# SERVICE BULLETIN

TR-7800, TR-7850

#860

SUBJECT: Memory Channel 7 Indicator Erratic

▼ CONTROL UNIT (X53-1180-XX) XX: 10(K), 61(W)(T)

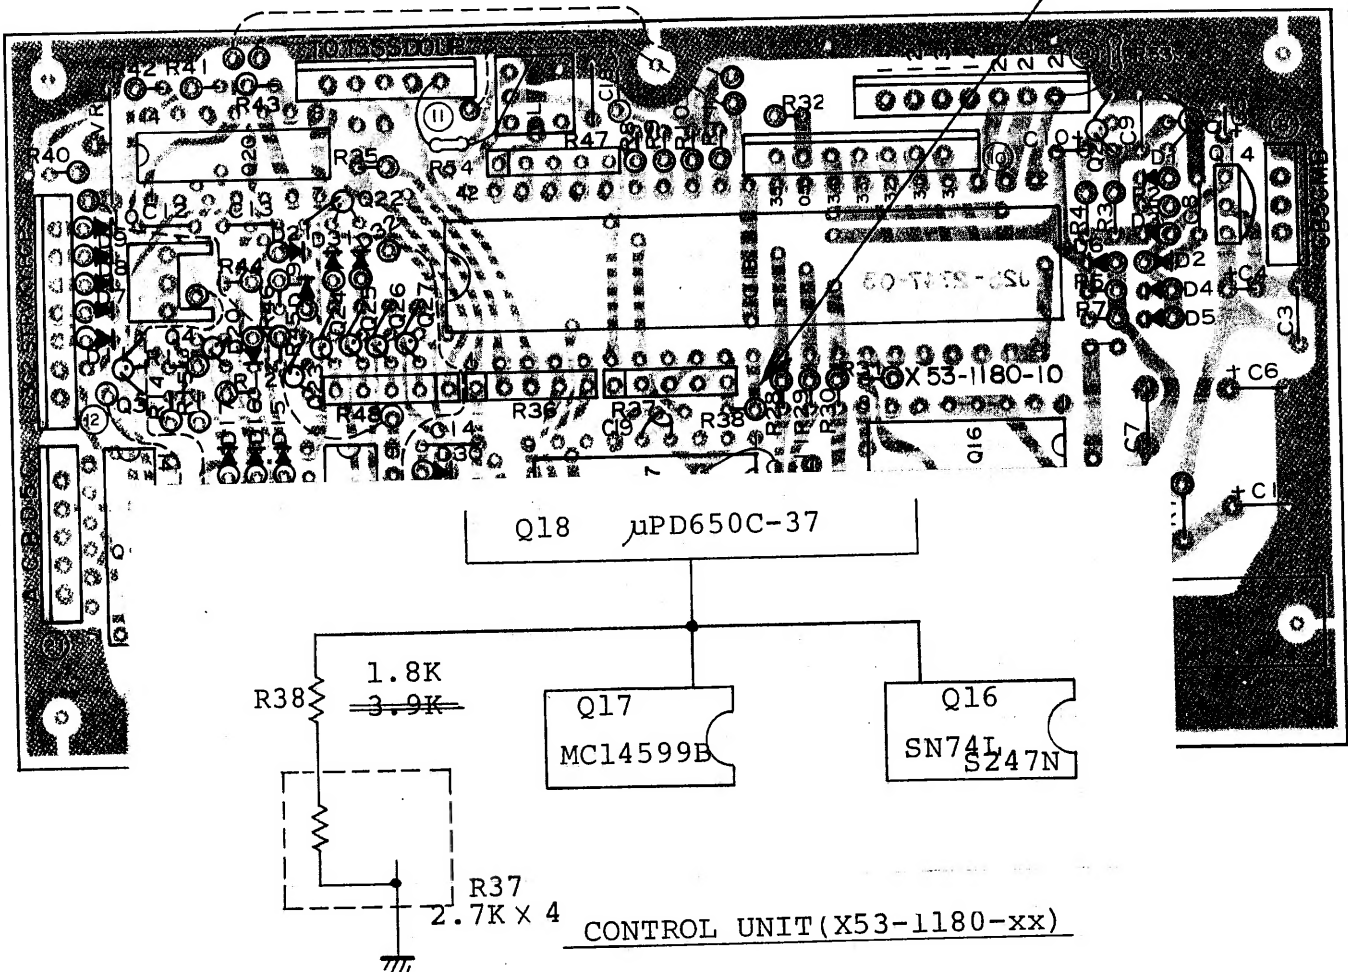
When Memory Channel 7 is selected, the LED may fail to indicate the number 7, although frequency is correctly recalled and all other operations are normal. Cause is incorrect voltage level at Q16 & Q17, and is related to individual differences between these IC's. Correction is by changing one resistor value on the Control unit.

~~3.9K~~  $\rightarrow$  1.8K

On the Control unit X53-1180-xx, replace R38 from 3.9k $\Omega$  to a 1.8k $\Omega$  resistor (RD14CB2E182J). No adjustments are required.
